## **CSA CONTAINER YARD NO. 2 SUBDIVISION**

Engineering Comments: FINAL PLAT COMMENTS (should be addressed prior to submitting the FINAL PLAT for review and/or signature by the City Engineer):

APPLICATION NUMBER 5 DATE March 2, 2023

# DETAIL SITE PLAN

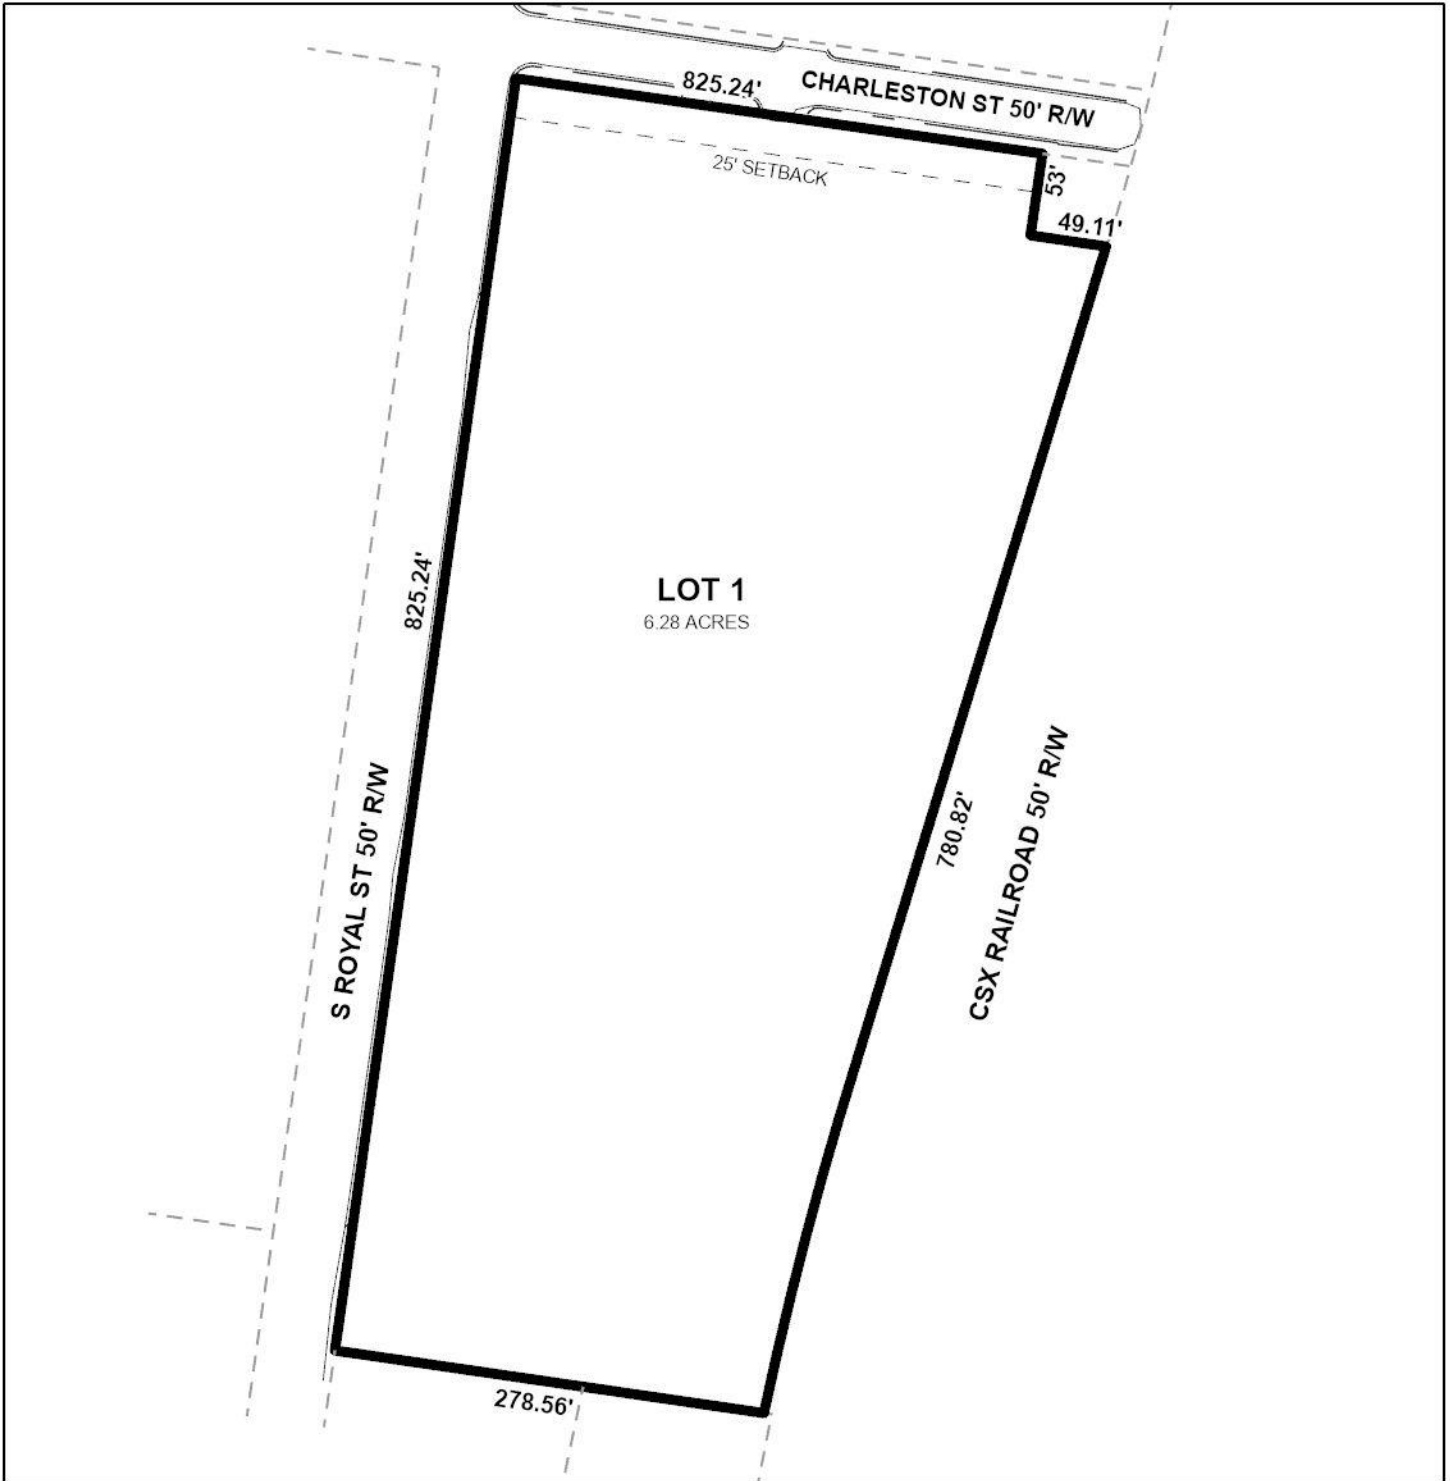
- B. Provide and label the monument set or found at each subdivision corner, including the east and south property lines.
- C. Show and label the MFFE (Minimum Finished Floor Elevation) on each lot that contains an A, AE, or X (shaded) flood zone designation. BFE = 12.

The site has frontage on South Royal Street and Charleston Street, both minor streets with curb-and-gutter, which have existing compliant 50-foot rights-of-way. Therefore, no dedication would be required. Therefore, the right-of-way width of South Royal and Charleston Streets should be retained on the Final Plat, if approved. Per Section V.D.6. of the Subdivision Regulations, the corner radius at South Royal Street and Charleston Street should be dedicated.

The preliminary plat submitted indicates a proposed 25-foot minimum building setback line along Charleston Street, and this should be retained on the Final Plat, if approved. However, there is not a proposed 25-foot minimum building setback illustrated along South Royal Street. If approved, a 25-foot minimum building setback should be illustrated on the Final Plat.

- 1) dedication of the corner radius of South Royal and Charleston Streets on the Final Plat;
- 2) retention of the 25-foot minimum building setback lines along Charleston Street on the Final Plat;

- 3) illustration of the 25-foot minimum building setback lines along South Royal Street on the Final Plat;
- 4) retention of the lot size on the Final Plat adjusted for corner radius dedication;
